Date: 2/27/03
To: All Niles Dealers and Representatives
From: The Technical Support Department
Subject: Use Of New IR Sensors With Older MSU

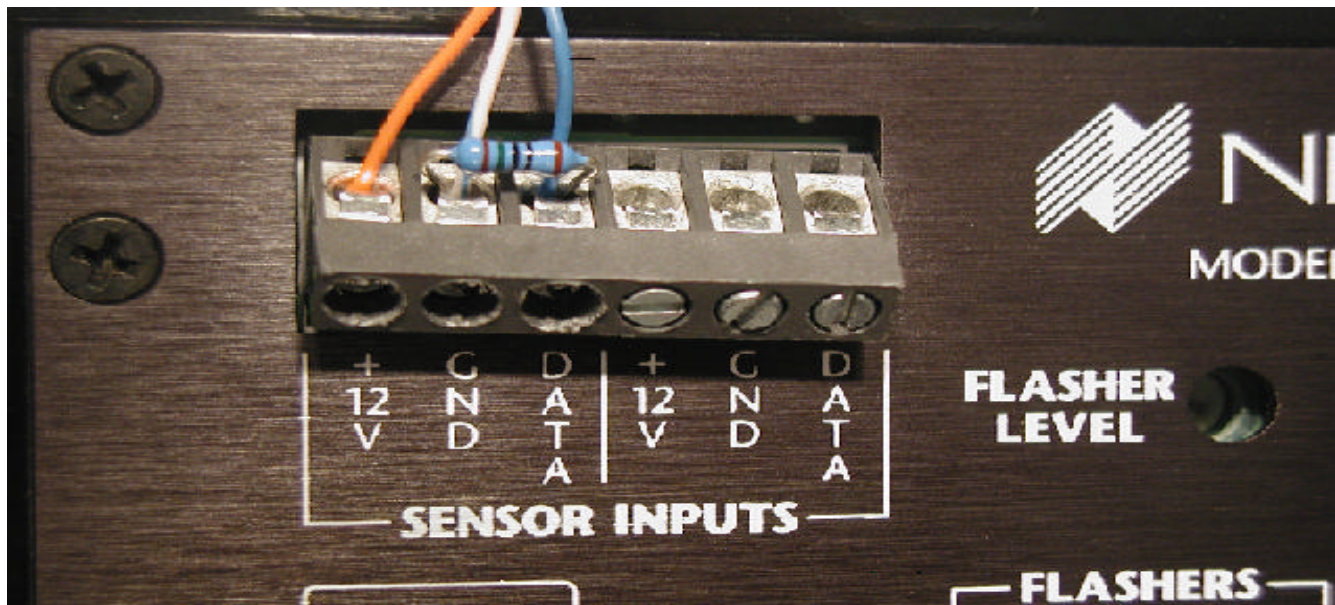
Niles will soon begin filling orders for the new line-up of IR Sensors, Main System Units and Flashers. It is possible to use the new sensors with the older IR MSUs such as the IRP-2+ and the IRP-6+. However, to maximize sensor performance it is necessary to connect a 150 ohms resistor across the ground and data terminals on the sensor input of the Main System Unit as shown in the photograph below. Remember, this only applies when using a *new* sensor on an *old* MSU.
